Regarding the Applicants assessment of Hydrogeology and Flood Risk

In the document *GREX_WED3_01 Applicants response to Written Submissions* I noted a failure to address issues I had raised regarding flood risk and the bomb store

BOMB STORE AT GLYN RHONWY, LLANBERIS

Structural Report

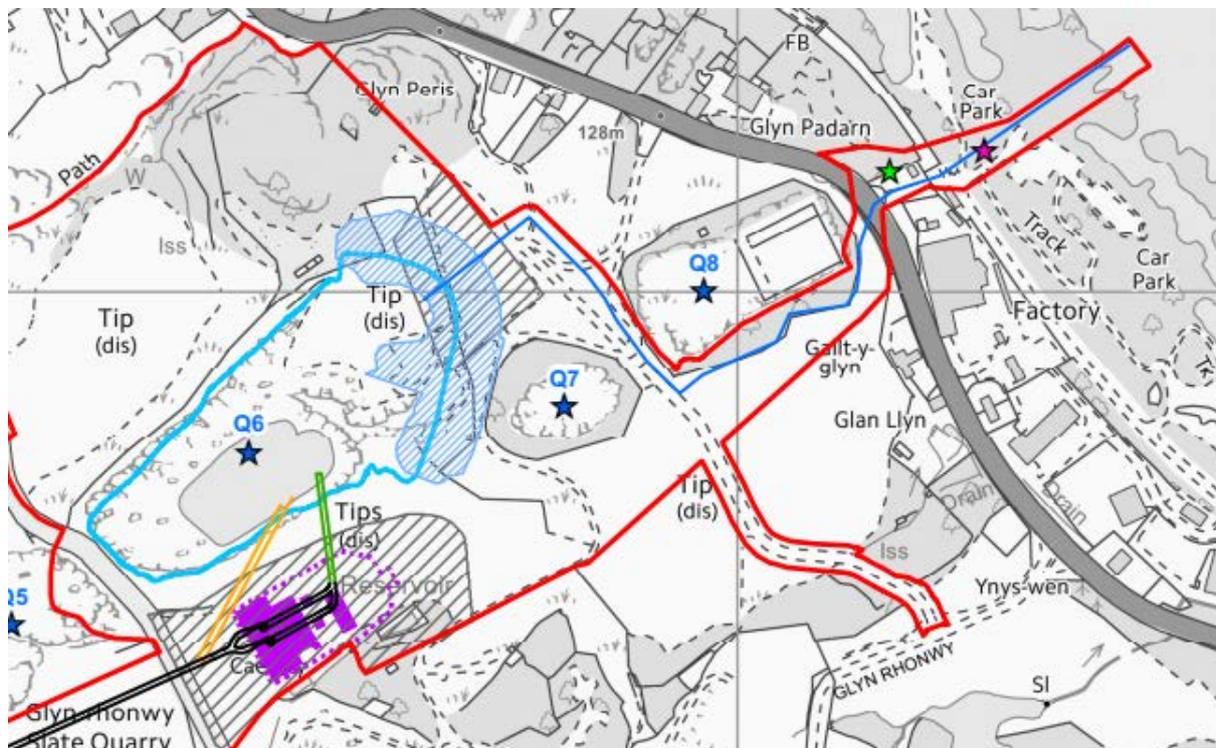
- risk of loss of containment due to large scale collapse of a quarry wall into the upper or lower ponds ..
- poor understanding of flowpaths connecting the whole quarry system deriving from earlier documented and undocumented quarry workings
- potential for collapse of nearby bomb store impacting integrity of tailpond dam
- confidentiality of breach analysis documentation

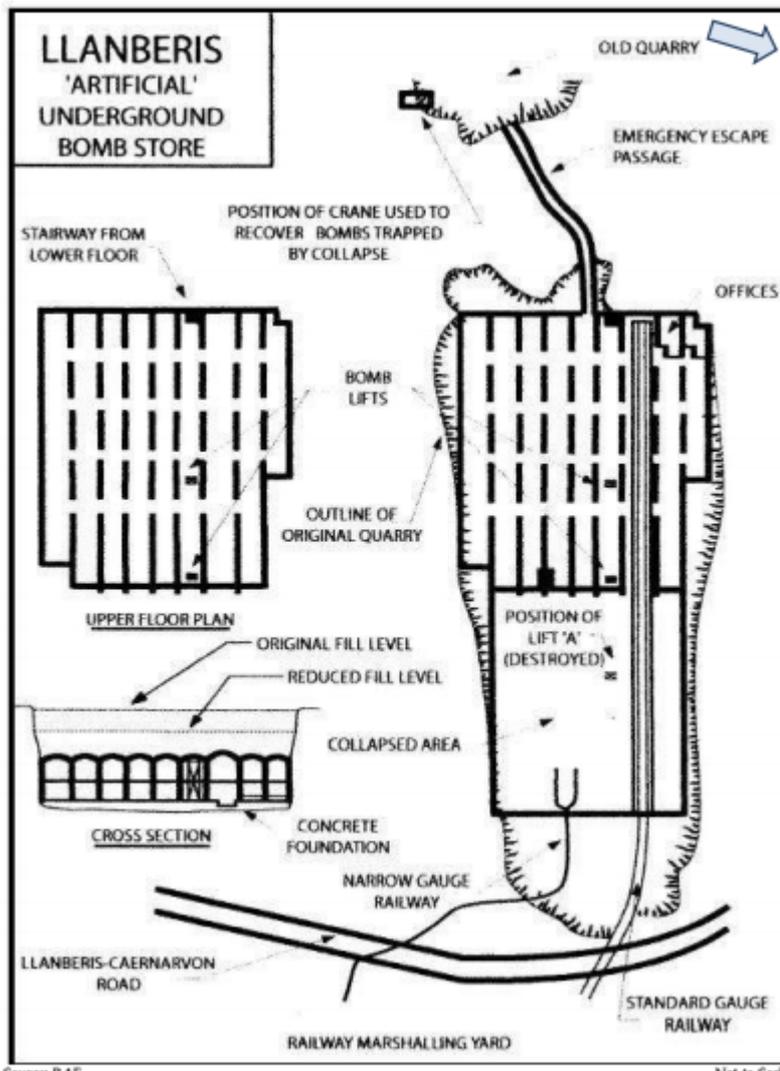
Mr Boswell responded only in relation to the issue of the bomb store, and remarked that since it lay outside the Applicants "red line" it was irrelevant to the enquiry. I strongly disagree with this dismissive approach. It is a void the size of a football pitch and approx 7m high overlain by approx 5m of slate overburden. It is the surviving back half of a structure which collapsed not long after construction. And it is approx 110m from the foot of the lower dam.

This map shows the Applicants site boundary in red just (by a matter of a meter or two) skirting the ground above the back end of the void which constitutes the remaining part of the bomb store – at the south east edge of the pit labelled Q8. The footprint of the tailpond dam shown shaded in blue shows that the foot of the dam is approx 110m from the back end (SE extent) of this void.

The picture above shows on the right the plan of the bomb store .. the “collapsed area” is now the clear open area which shows on aerial images and Applicant’s maps. The upper half of the plan is the still existing void hidden under slate overburden which extends almost to the Applicants site boundary.

Its condition has not been recently assessed for nearly 20 years, it is subject to degradation and it is not as far as I know being monitored. Whoever owns the structure and wherever it is, if its collapse could threaten the integrity of a dam and the safety of the public then it needs to be considered.
